CITY OF MERCER ISLAND **REVISED**

1. AB 6002: Draft ADA Transition Plan

TITLE:	AB 6002: Draft ADA Transition Plan	<input checked="" type="checkbox"/> Discussion Only <input type="checkbox"/> Action Needed: <input type="checkbox"/> Motion <input type="checkbox"/> Ordinance <input type="checkbox"/> Resolution
RECOMMENDED ACTION:	Receive report. No formal action required.

ADA Transition Plan

CITY OF MERCER ISLAND STANDARD DETAILS STREETS	
	DRIVEWAY CROSS-SECTION ALTERNATE "B"	
11/23/99	NO SCALE	ST-20

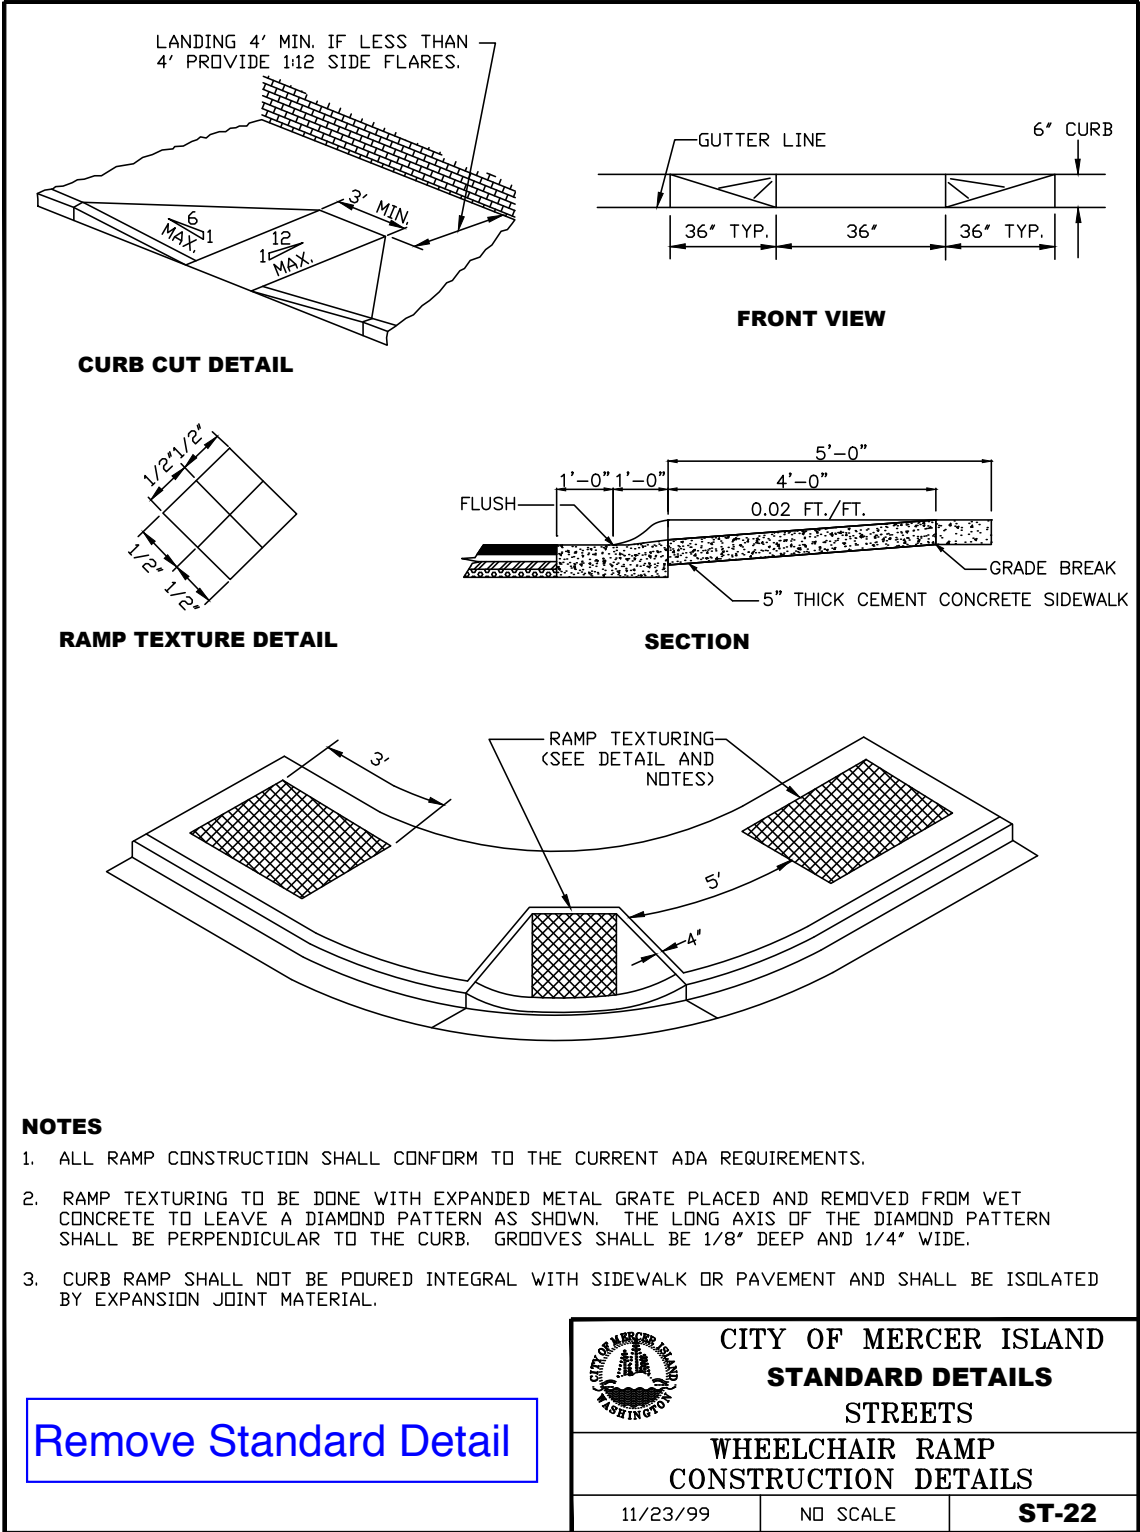
Allow for single curb ramp on a corner for alterations where existing physical constraints prevent two curb ramps from being installed.

Include two curb ramps on each corner as the preferred layout.

Revise reference.

CITY OF MERCER ISLAND STANDARD DETAILS STREETS	
	SINGLE DIRECTION B CURB RAMP	
8/14/2015	NO SCALE	ST-22B

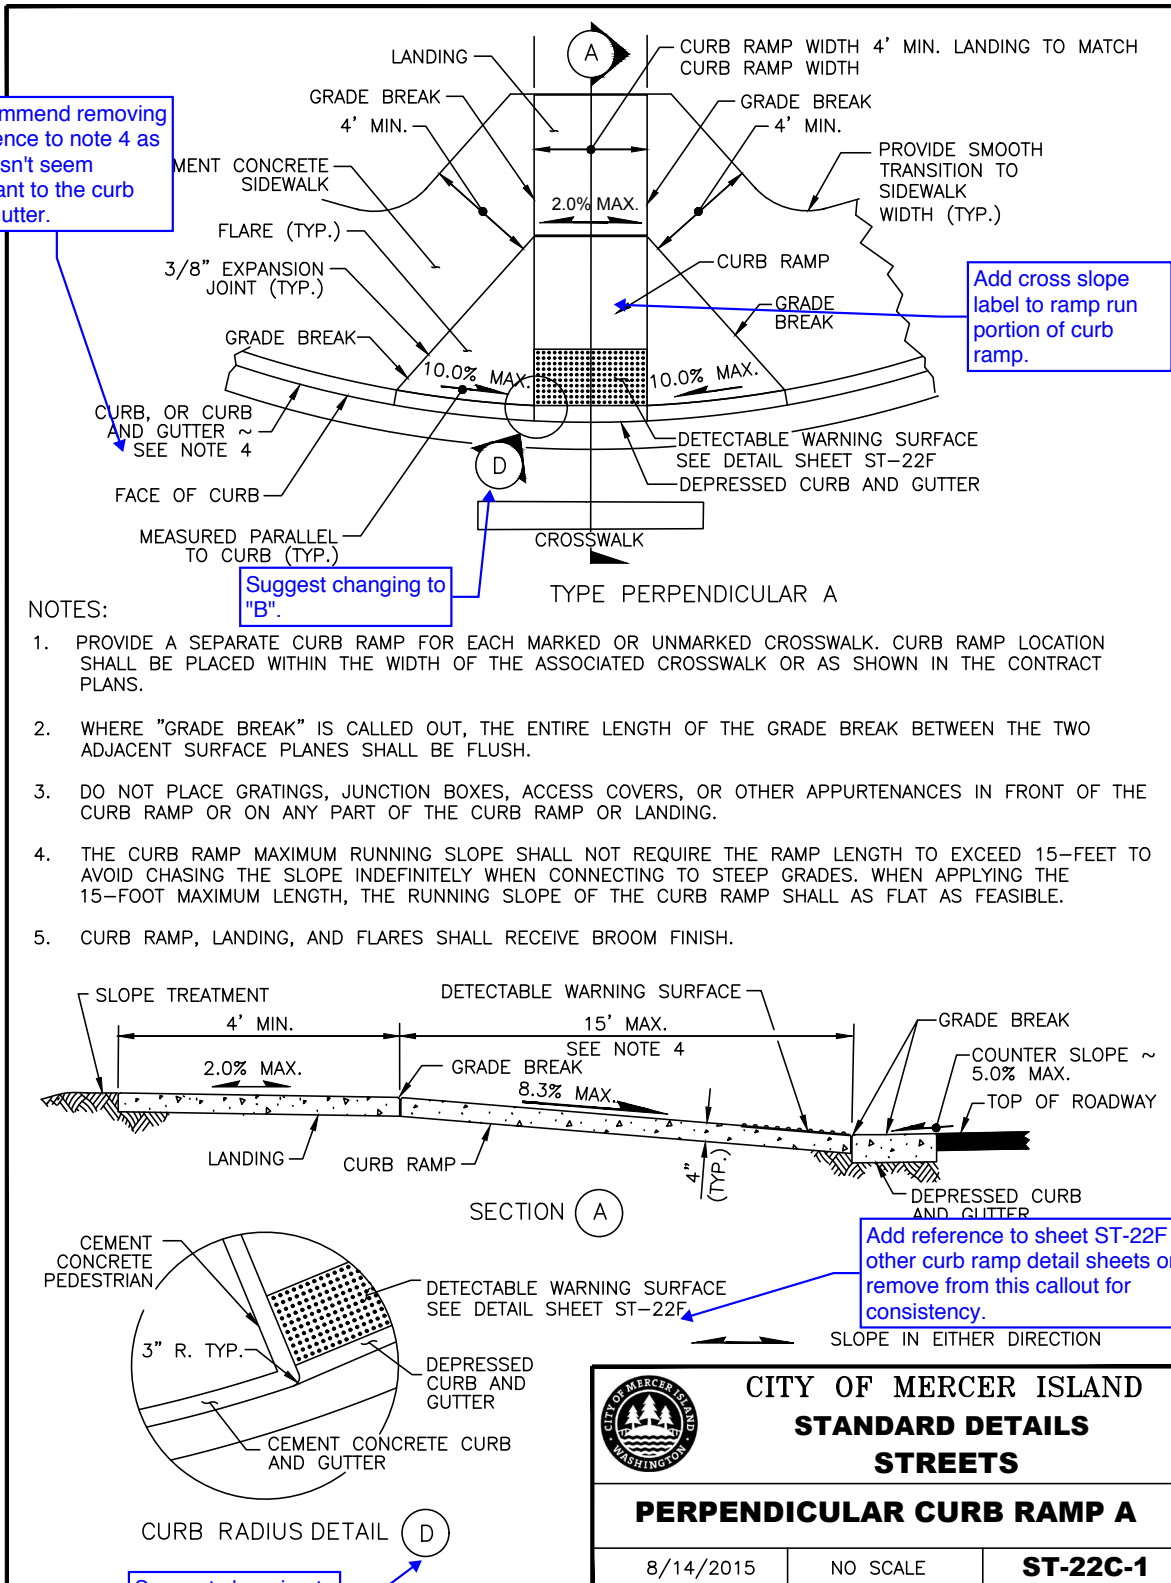
Recommend removing reference to note 4 as it doesn't seem relevant to the curb and gutter.

Add cross slope label to ramp run portion of curb ramp.

Add reference to sheet ST-22F to other curb ramp detail sheets or remove from this callout for consistency.
